SERVICE BULLETIN

Classification: EL12-034a	Reference: NTB12-043a	Date: May 18, 2012
------------------------------	--------------------------	-----------------------

2008 – 2012 ROGUE ENGINE HARNESS REPLACEMENT

APPLIED VEHICLES: 2008 – 2012 Rogue (S35)
APPLIED VIN: Built on or before JN8AS5M(*) (*)CW 713595
APPLIED DATE: Built on or before March 28, 2012

Figure 1

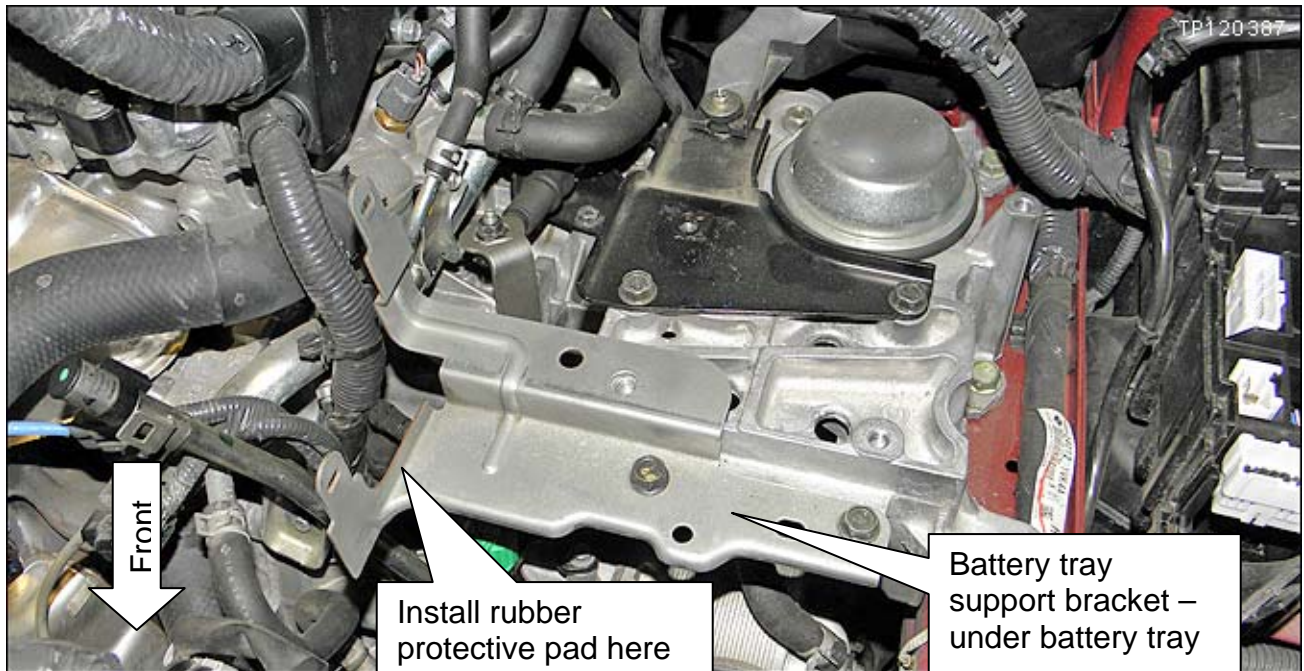
If for any reason the engine harness is replaced, during the replacement of the harness, install a rubber protective pad on the battery tray support bracket at the location shown in Figure 1 below. Refer to the Service Procedure for installation instructions.

Figure 2

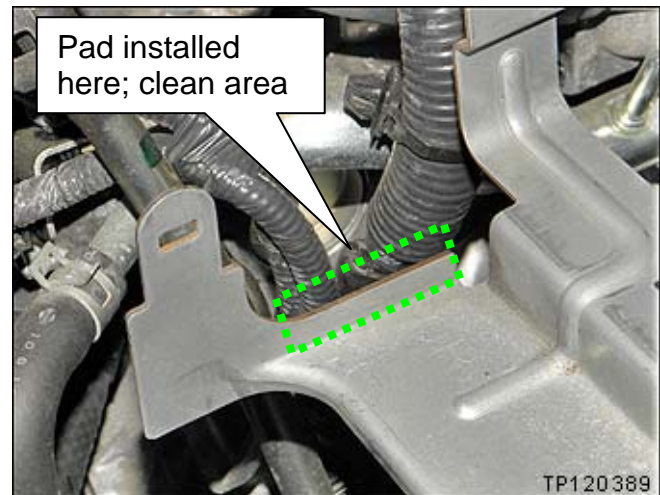
2. Clean the area where the protective pad will be installed.
 - Installation area is shown with dashed line.
 - Clean both sides of the bracket edge. Pad will be folded over and attached to both sides.

Figure 3

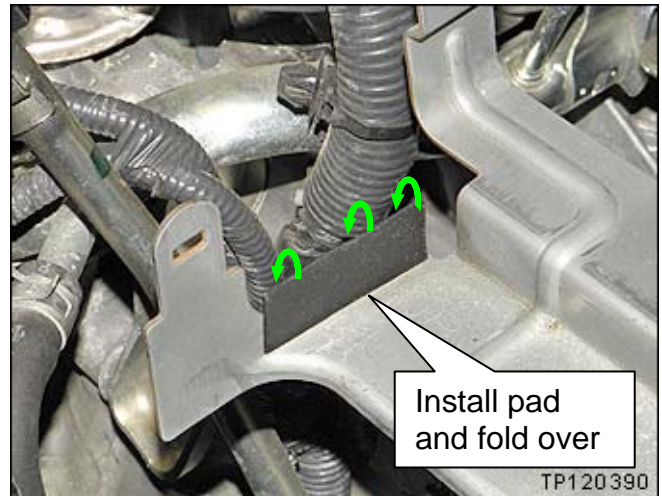
3. Attach the rubber protective pad as shown.
4. Fold the protective pad over the bracket edge so it covers and sticks to both side.
